CITY OF CORONA
Department of Water and Power
WRF3 Sewer Lift Station
CONTRACT CHANGE ORDER NO. 2

PROJECT DESCRIPTION: Construct a sewer lift station.

PROJECT NO: NIB 21-012CA, 2018-11

DESCRIPTION OF CHANGES AND/OR EXTRA WORK: Extra work to install lift station shoring resulting from unknown groundwater conditions.

Figure 1

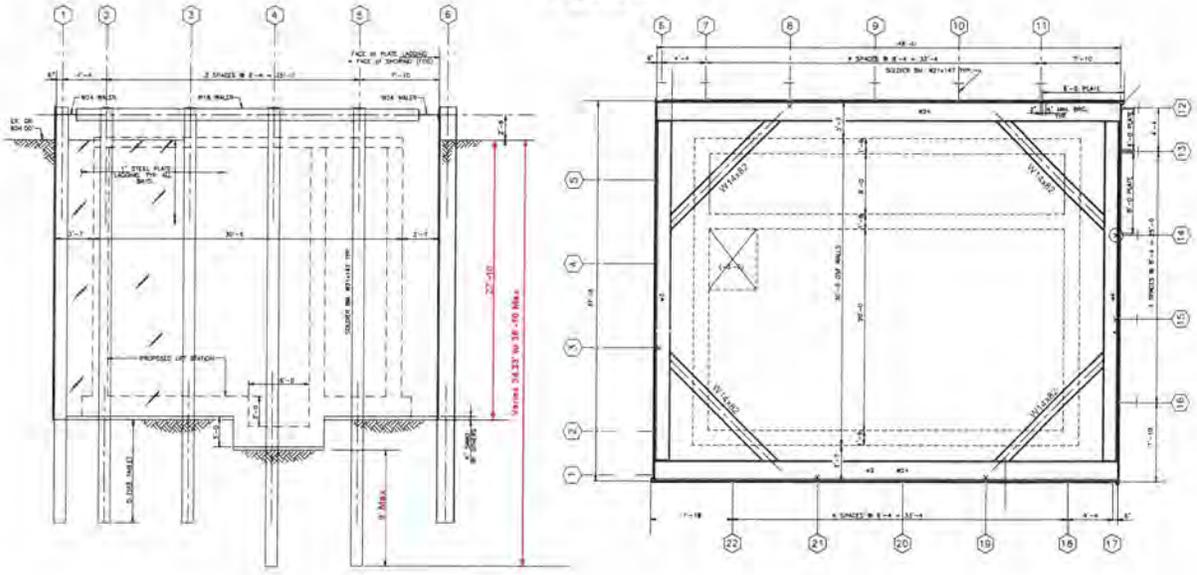
As you know, McMahan was to install the shoring system depicted in Figure 1, which consisted to drilling and setting 22 soldier piles to a maximum depth of approximately 37' below the ground surface.

Figure 2

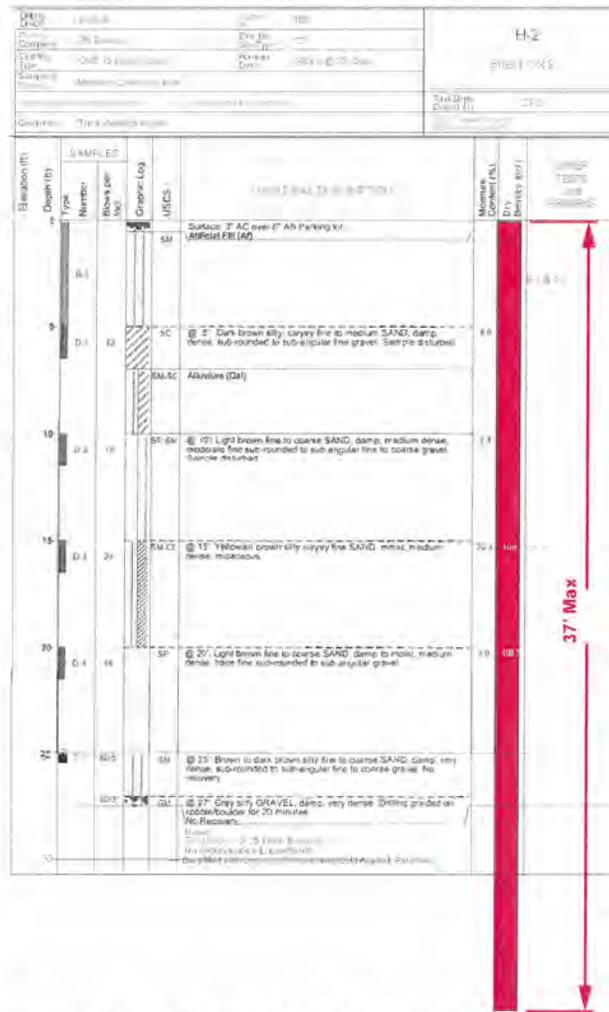
Graphically, Figure 2 duplicates Test Boring H-2 with the depth range of soldier pile drilling superimposed upon it (Boring H-1 similar).

Note that at 27' of depth, the log indicates that the drilling tool encountered "grey silty gravel, damp, very dense. Drilling grinded on cobble/boulder for 20 minutes" and, at a depth of 27.25' the CME's auger encountered "refusal" to further auger advancement.

In contrast, the notes at the bottom of Boring H-1 state the following at the exact same depth of 27': "grey silty

gravel, damp, very dense. Sample pounded on 1" rock. Drilling went [to] 2" in 45 minutes." [emphasis added]

Figure 3

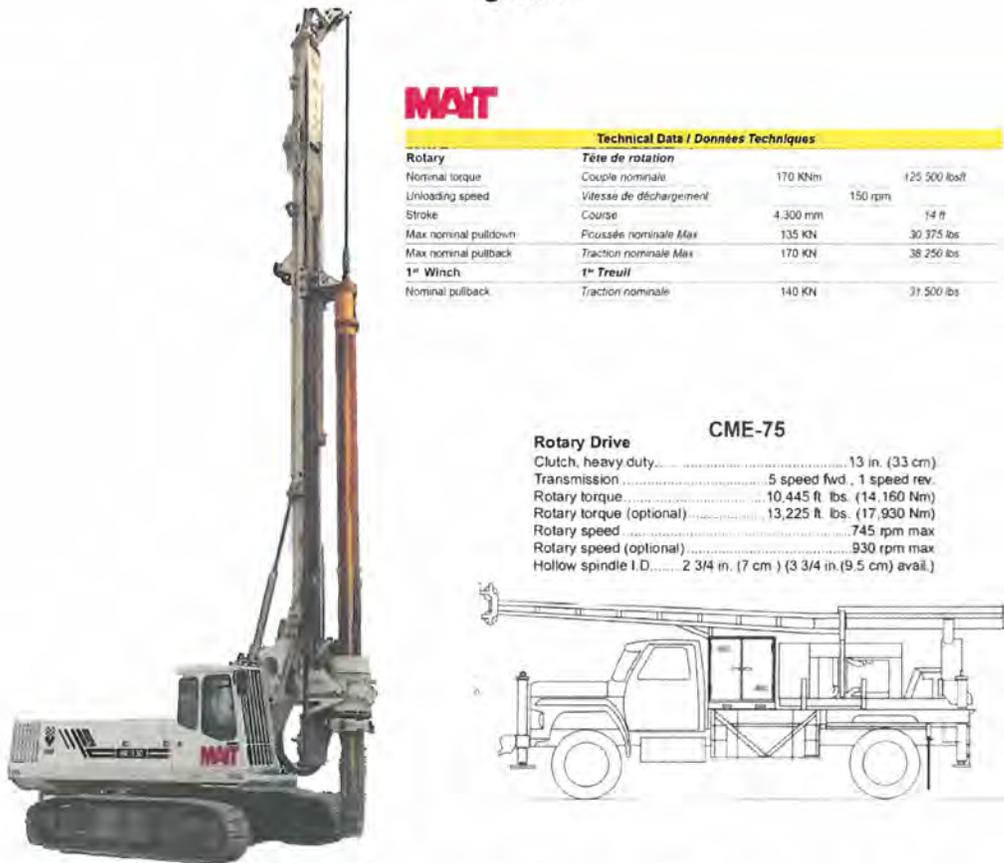
It must be understood, that "refusal" to a relatively small CME-75 geotechnical drill rig does not necessarily connote refusal to either a large vibratory hammer or to a much larger and more powerful drill rig such as the MAIT HR130 drill rig McMahon deployed to the project. Figure 3 compares the size, and torque between the two rigs.

The available torque of the MAIT, at 125,000 ft*lbs is roughly 12 times greater than the 10,445 ft*lbs of torque deliverable by the CME-75 to advance its auger.

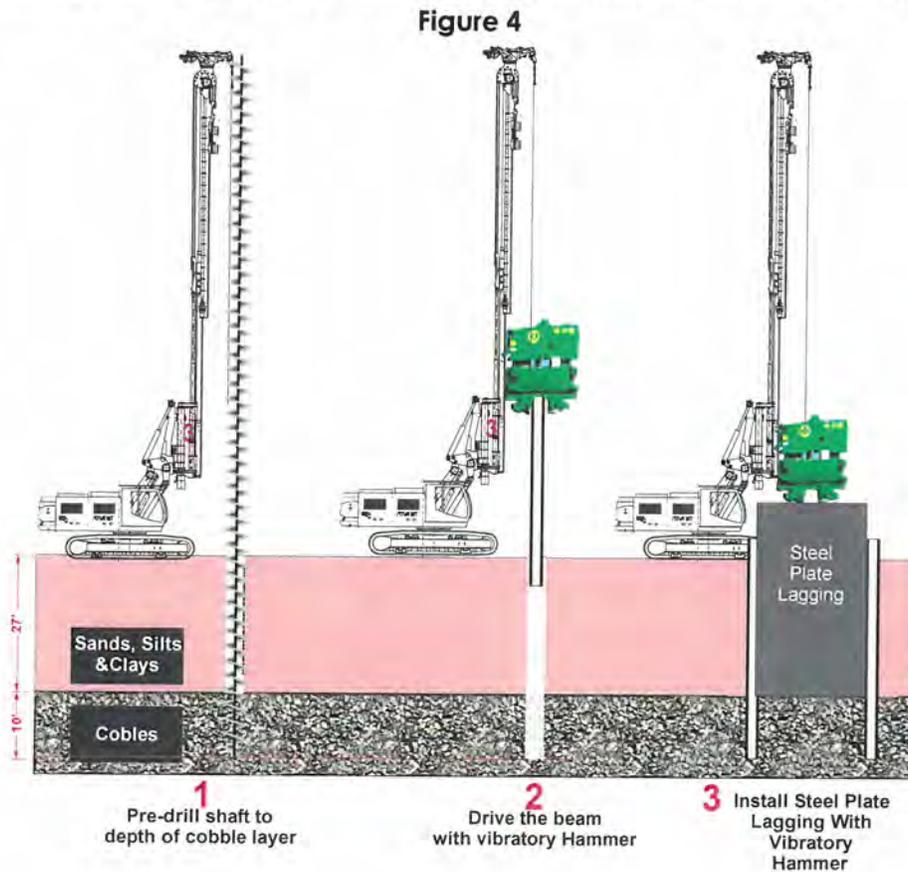
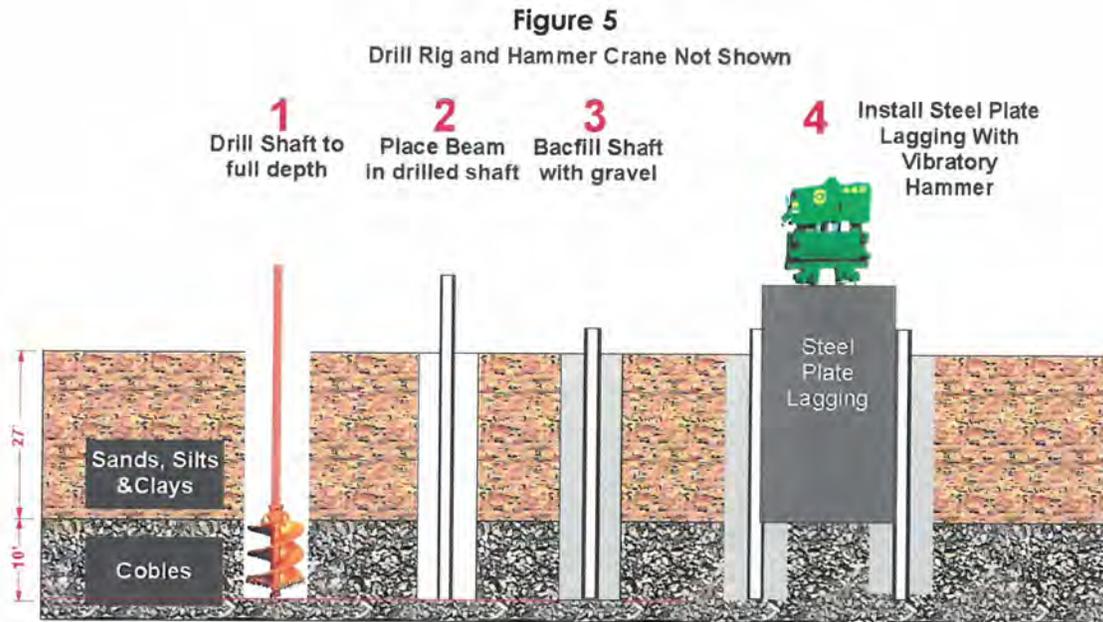
the beams had been placed, steel plates would be driven between the soldier piles so as to support the ground spanning between the beams to the depth of lift station excavation which was above the gravel/cobble layer. The sequence of intended installation is depicted in Figure 4.

McMahon also reasonably concluded that if the lower gravel and cobble would not sufficiently displace under the energy provided by the vibratory hammer and thereby impede pile advancement, then McMahon would simply drill the entire shaft with the Mait HR 130, set the beam into a dry shaft and backfill with either sand, gravel or a lean cement/sand mix.

Steel lagging plates would still be installed with the vibratory hammer because, in both cases, the plates extend to the same depth required for the excavation which terminated above the represented gravel/cobble layer. The full-drill method is graphically depicted in Figure 5, and McMahon reasonably determined that using the full-depth method would produce 4 to 5 beam installations per day.

Figure 6

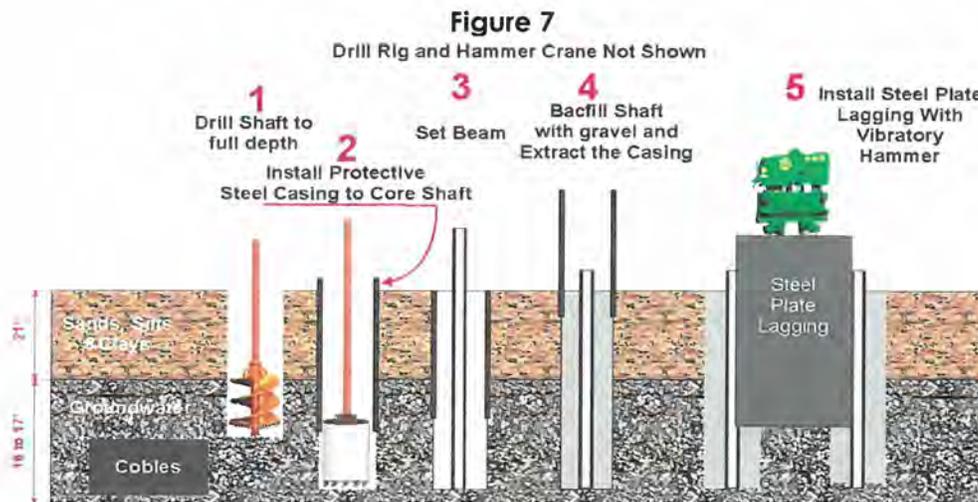
On its very first pile, McMahon advanced the auger as expected through the first 21' of depth. At a depth just below 21' the drill action became markedly different as it chattered and shook the rig indicating that the auger was encountering much larger material than the sandy material represented to exist at that depth. Acting prudently, McMahon then abandoned the CFA method (Figure 4) and started drilling as shown in Figure 5. Unlike the CFA method, this method requires the auger to make multiple up and down passes thus creating an open shaft. When the auger reached just below a depth of 21', McMahon encountered the groundwater that was represented to reside well below the zone of drilling. To make matters worse, at the same depth, McMahon also encountered an abundance of nested cobbles **and** boulders within the shaft at an elevation 6.5' to 7.5' higher than the elevation the cobbles were (27.5') represented to exist by the City's geotechnical study.

On the one hand, even if the hole was entirely dry, as was represented by the City's Bidding Documents, when the auger enters a zone of nested cobbles and boulders, whatever amount of smaller sized soil material the auger flights initially capture, gets shaken off the flights by the turbulence and vibration that occurs as the auger gets knocked back and forth by the much larger and harder cobble and boulder material. On the other hand, when below the groundwater table, even if the hole consisted entirely of the sandy material represented to exist in the upper 27' of the shaft, and every downward pass fills all the flights with soil, then, when the auger is raised through the column of water, the water washes the sandy soil off the flights leaving very little to be spun off at the ground surface.

McMahon was faced with both conditions simultaneously, and pursuant to Standard Industry Practice, McMahon realized that polymer drilling slurry should be introduced into the shaft to stabilize the shaft walls and help maintain more material onto the flights during its ascent. The polymer slurry coats the shaft walls and increases the viscosity of the water to that similar to molasses. It is a benign substance and specifically designed with a relatively short life span and to break down to water at the end of its short life. Though it performs in a like manner as a bentonite slurry to stabilize the shaft and reduce auger wash-off (bentonite is clay particles mixed with water to form a clayey mud-like substance that does not break back down to water), when a site needs to be dewatered, as this site was discovered to require, polymer use is superior to that of bentonite because it will not clog the dewatering pumps.
